Technical Service Bulletin

57 Door cannot be opened from outside, it can only be opened from inside

57 13 87 2029151/4 March 27, 2013. Supersedes Technical Service Bulletin Group 57 number 12-80 dated November 9, 2012 for reasons listed below.

Figure 4. Holding the yellow sleeve in the lock.

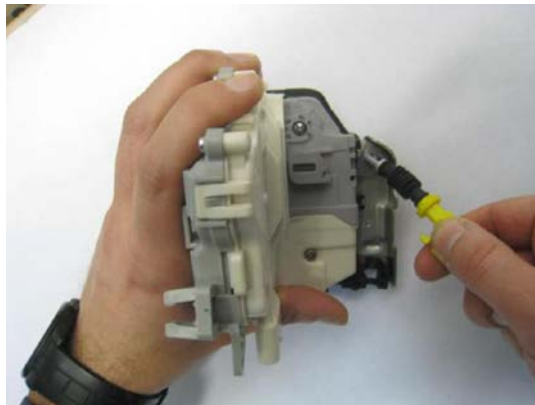
- a. Position the Bowden cable by holding the yellow sleeve in the lock (Figure 4).

Figure 6. Do not turn the lock or the mounting bar.

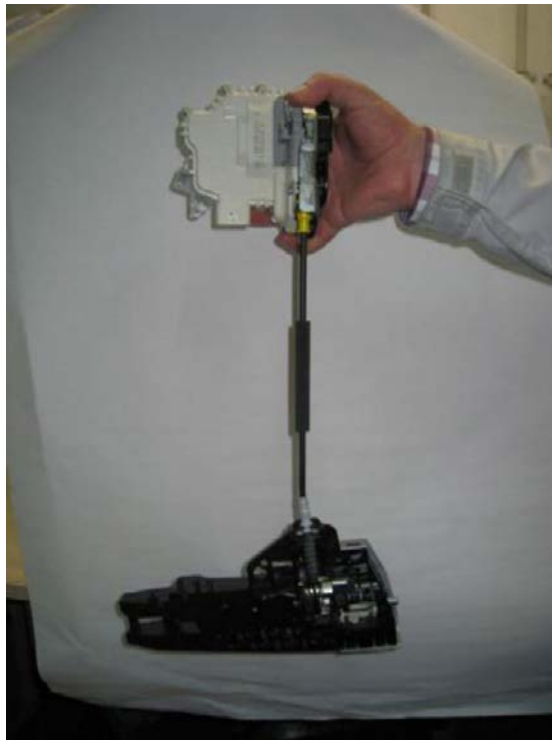
- c. Do *not* twist the Bowden cable after the installation. To avoid twisting the cable, turn neither the lock nor the mounting bar (Figure 6).
